ONSITE SANITATION City of Portland – Bureau of Development Services 1900 SW 4th Avenue, Portland, Oregon 97201 – 503-823-7300 – septic@portlandoregon.gov

SEPTIC REVIEW CERTIFICATION

, species of property (1)		
STEP 1- Complete the following:		
Address of Proposed Work: 36930 E HIST COLUMBIA RIVER HWY, CORBETT, OR 97019		N
Property Map & Tax Lot #: 1N4E35BA -02201 Alternate Acct #: R R665600200	P	<u>၂</u> -
Description of proposed work for this Septic Planning Review Proposal to place new building to house fire department vehicles, weight room, supply & hvac rooms, laundry room, & restroom. Decomm existing septic tank under proposed building, re-route existing sanitary lines.	Permit No.	101353-
Change in number of bedrooms? Yes No # existing bedrooms # bedrooms at completion Applicant's Name Evergreen Remodeling, Inc / Gary Purvine		υ Γ
Applicant E-mail garypurvine@aol.com Phone 503-307-2427		
 STEP 2- Submit: This form with all required submittals listed on page 2. Separate properties require individual applications. Refer to the current Septic Evaluation Application for fees. Submit complete Septic Review Certification submittal package via: E-mail septic@portlandoregon.gov Info

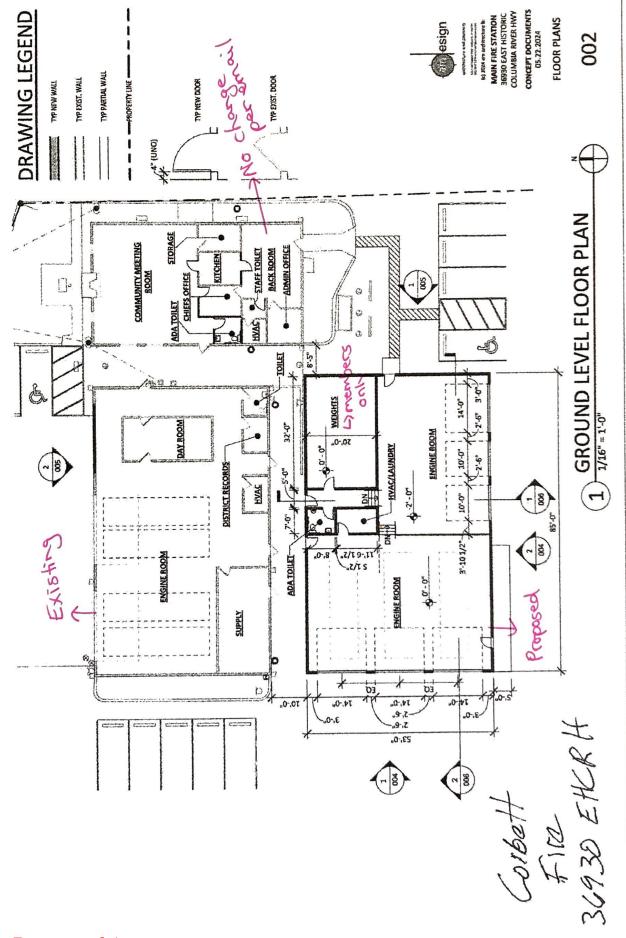
flow from the weight room. Site visit conducted 4/11/25. Stormwater plan likely will be tanks pumping to ROW per applicant; back-up plan is stori	nwater	_
wale alongside existing berm, estimate any swale would be 50ft from replacement DF area. If swale would get bigger, repair area must be treatment	ent.	
Lindsey Reschke Digitally signed by Lindsey Reschke Date: 2025.04.21 13:17:30 -07'00' 4/21/25		_
Multnomah County Sanitarian Date

25-001353-SE Rev 2 () () () E Historic Columbia River Hut 4/11 25 Site Visit اله م ydl gw roll P existing Say) elishing N *Apardor 3 82' 1=27 -022895-SE, Septic decomm decomm'ed 2 inspection foundation inspection 83' commercial use 13 added Effluent filter to be 90'z per michaels is really needed + 15-16 A Existing system proposed training taper description 8 Approx 50 ft to ede age 2 of 15 west files not be with 130' 8:00 relier heren ESX 10 * 05×100 est 110 Xo 530,
